SYDNEY ELECTRICITY

OVERHEAD CONSTRUCTION
33kV, 66kV & 132kV SPUN CONCRETE POLES
SINGLE POLE STRUCTURES
LOCATION OF POLE DRESSING FIXTURES

SIZE	DWG. NUMBER	AMD
A1	118306	2

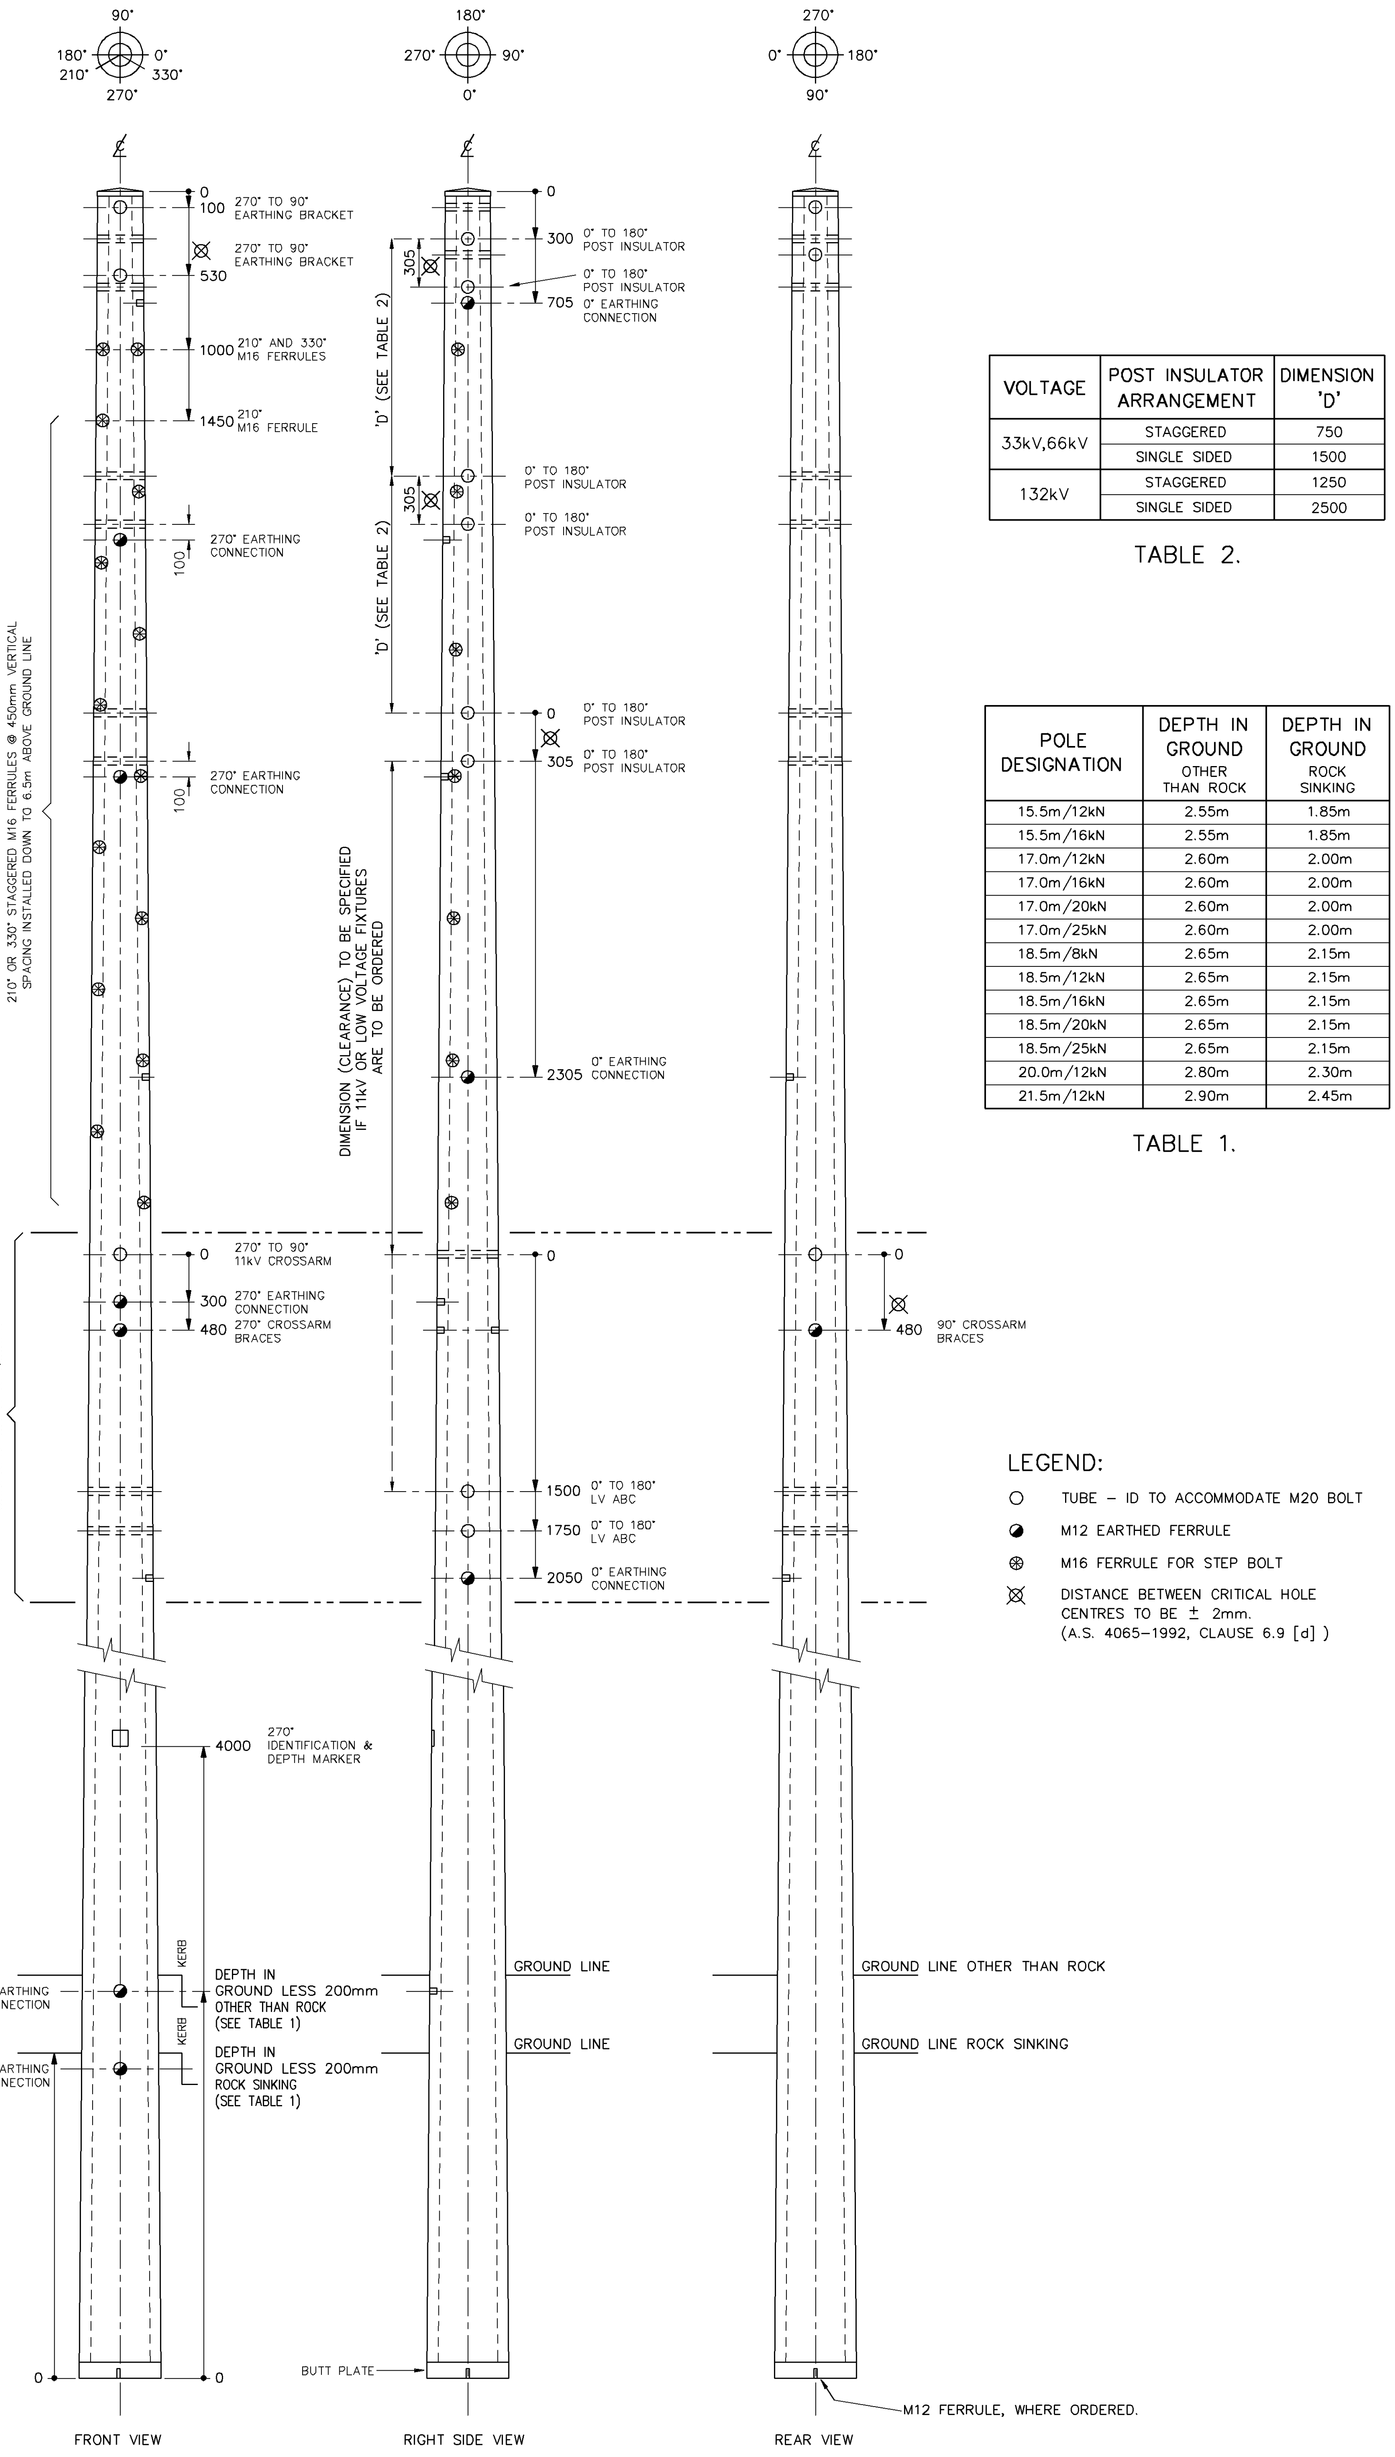
1. THIRD COLUMN ADDED TO TABLE 1. TO SHOW DEPTH IN ROCK. NEW GROUND LINE FOR ROCK SHOWN REF F10.
AMC 29-4-93
PN 29456
CHECKED KEM

2. REF.F2: DIMENSION 530 WAS 400. REF.E2, 3,4 & C7 AND LEGEND: SYMBOL ⊠ ADDED. REF. C,E,F,12: M12 FERRULE ADDED.
A.J.E. 28-9-93
P.No. 500010
Ckd: M.P. App: M.P.
